Product/Process Change Notice (PCN)

PCN_WE_UTUNIT_20130612_750871630_MiBr

Product Affected: 750871630

Old:

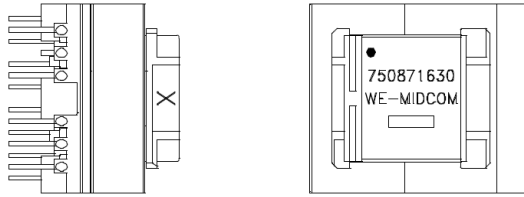
1. Change WE-MIDCOM to WE logo.
2. Add a second marking option. Now the marking can be placed on the top of the component like before or on the core side.
